Application for Waiver from Construction Standards for Public Water Systems

Water System Name: Portland Water Bureau

Project or Facility: SW Alder St & 6th Ave

Waiver ID: 586-2026

Figure 1: Simplified plan view depicting the water/sewer conflict.

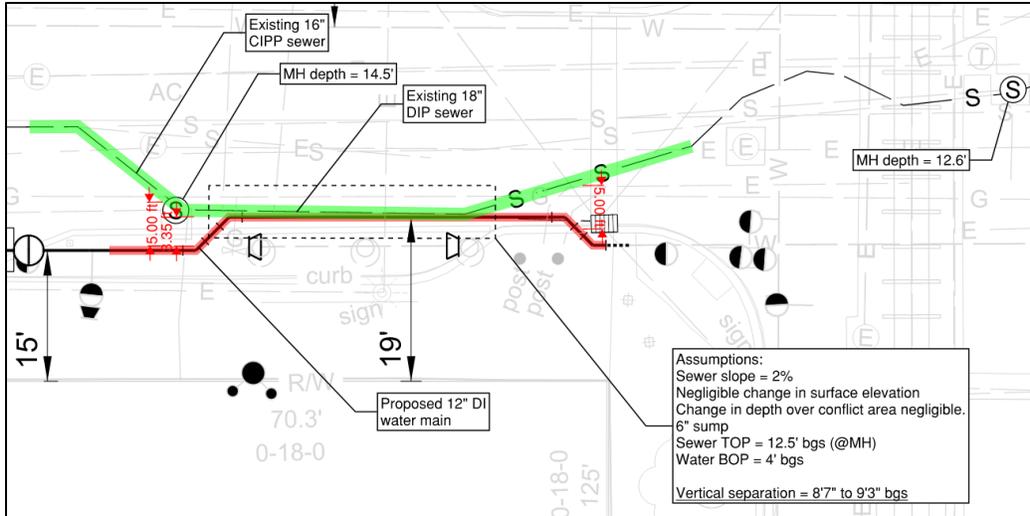
An existing 80' section of 12" ductile iron water main in SW Alder St near 6th Ave is being relocated to accommodate a new public transportation shelter. The pipe currently has about 3.5' of parallel horizontal separation from an existing 18" sewer. The proposed water alignment includes 6' of pipe with 1'-3.5' of separation creating a Zone 2 conflict (0+30A to 0+36A, red callout #1 on sheet 2 of 3 on attached plans), 32' of pipe with about 1' of separation creating a Zone 3 conflict (0+36A to 0+68A, callout #2), and 6' of pipe with 1'-5' of separation creating a Zone 2 conflict (0+68A to 0+78A, callout #3). A different segment of water pipe near 10th Ave will cross an existing sewer pipe at a shallow angle, creating a Zone 2 conflict for 20' where it is within 5' offset of the sewer (0+00B to 0+20B, callout #4 on sheet 3 of 3). Please see attached Figure 1 for a simplified plan view of the proposed conflict, and Figure 2 for a cross section view of the proposed conflict.

Plan Review Coordinator's notes: CLSM and polywrap sleeve are acceptable mitigations to the zone 2 conflict.

Figure 2: Cross-section of proposed bus shelter, proposed water pipe, and existing sewer where the Zone 3 conflict exists.

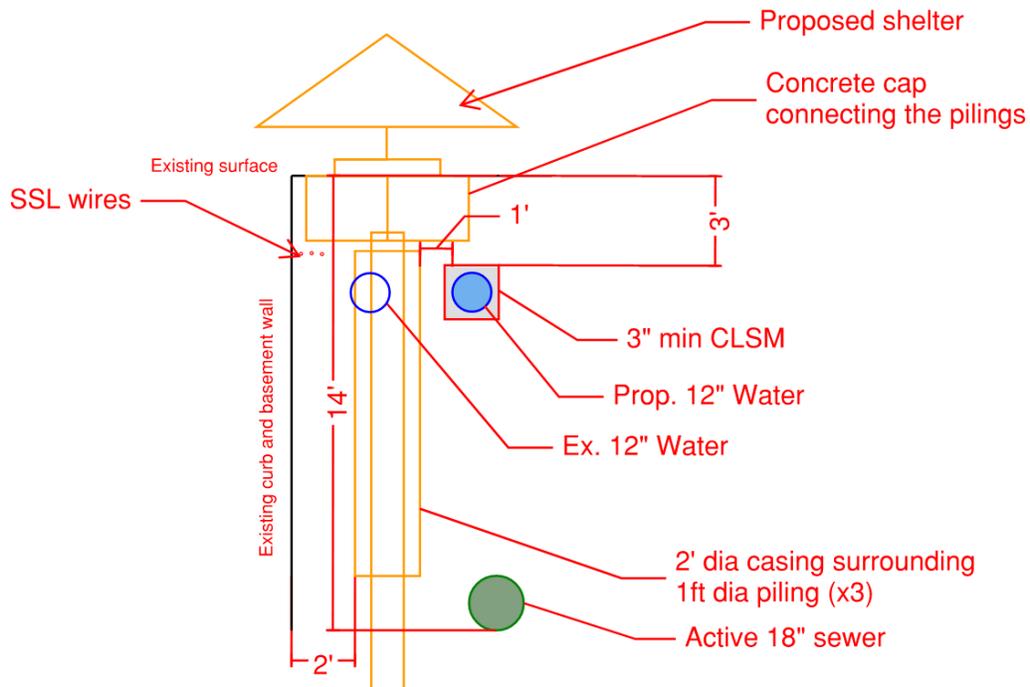
Condition of Existing Sewer: The sewer in conflict is an 18" DIP main installed in 1976, between 12.5'-14.5' deep. It is part of a combined sewer system which does have risk of surcharge in a 2-year, 5-year, and 25-year storm. The vertical separation is approximately 9' skin-to-skin. There are
